August 27, 2001

VIRGINIA ELECTRIC AND POWER COMPANY
NORTH ANNA POWER STATION UNITS 1 AND 2
PROPOSED IMPROVED TECHNICAL SPECIFICATIONS
REQUEST FOR ADDITIONAL INFORMATION – SPECIFICATION 3.3.1

North Anna Improved Technical Specifications (ITS) Review Comments
ITS Section 3.3, Instrumentation
LCO 3.3.1, RTS Instrumentation

TABLE 3.3-1 (Continued)

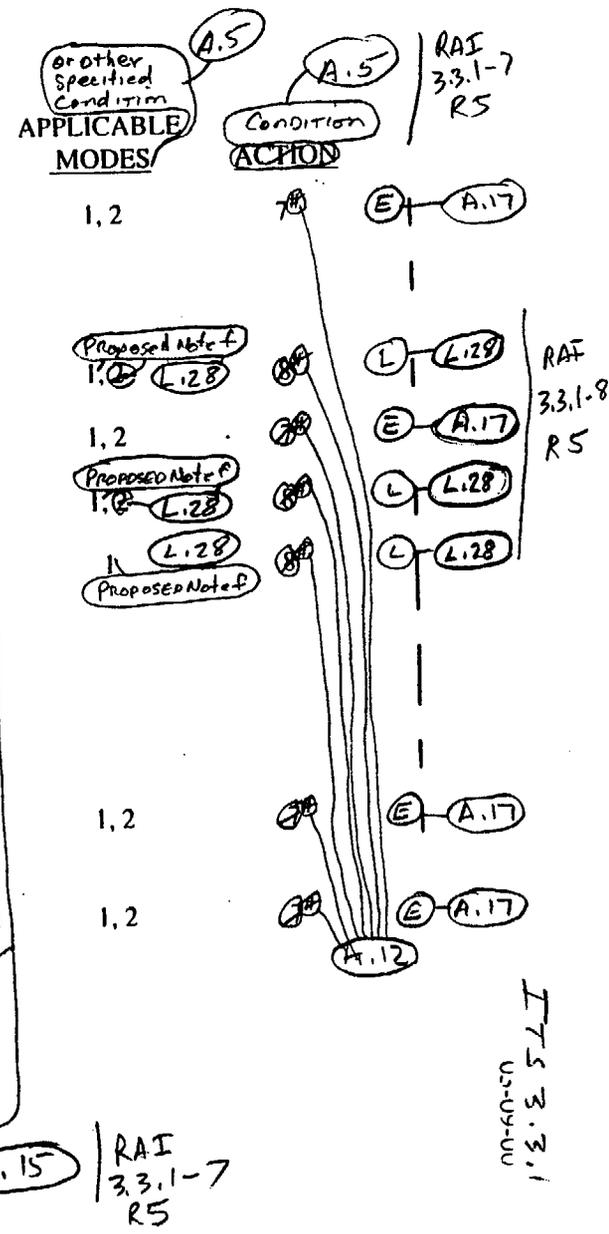
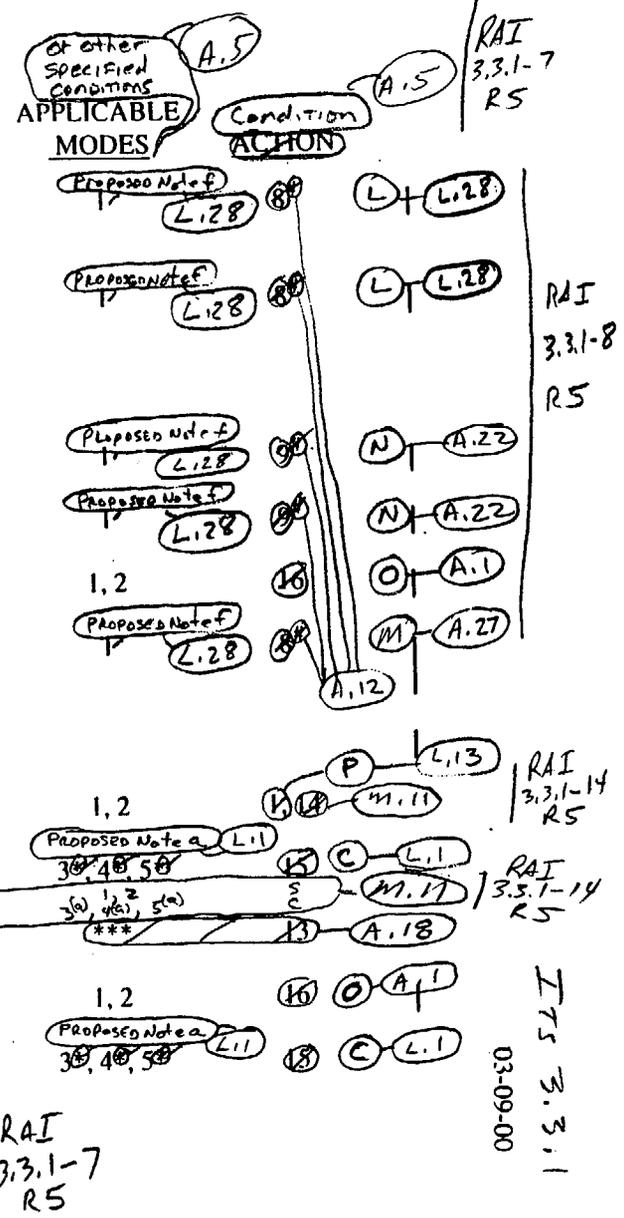
Comment#1 - Proposed changes to CTS Applicabilities represent less restrictive changes to the plant licensing basis because the ITS requires that the functions be operable in Mode 1 above P-7 (10% RTP) whereas, CTS require the same functions to be operable in Mode 1 (> 5% RTP) or Modes 1 and 2 (\geq 5% RTP). These less restrictive changes are not evaluated in the DOCs.

Comment#2 - ITS function 11 (Reactor Coolant Pump Breaker Position) Applicability changes are not discussed in DOC A.9.

Comment#3 - ITS function 20 (RCP Breaker Position) is referenced in the DOC but changes not listed in the ITS references. Also, the CTS requires total channels to be 1/breaker whereas, the ITS requires 1/RCP. This change is not evaluated in a DOC.

Response: The Company agrees with Comment 1. DOC A.9 has been eliminated and DOC L.28 is added to address the change in applicability.

The Company agrees with Comment 2. ITS function 11 has been added to DOC L.28.

The Company agrees with Comment 3. CTS is changed to delete 1/breaker and add 1/RCP with DOC A.27 modified to include the change.
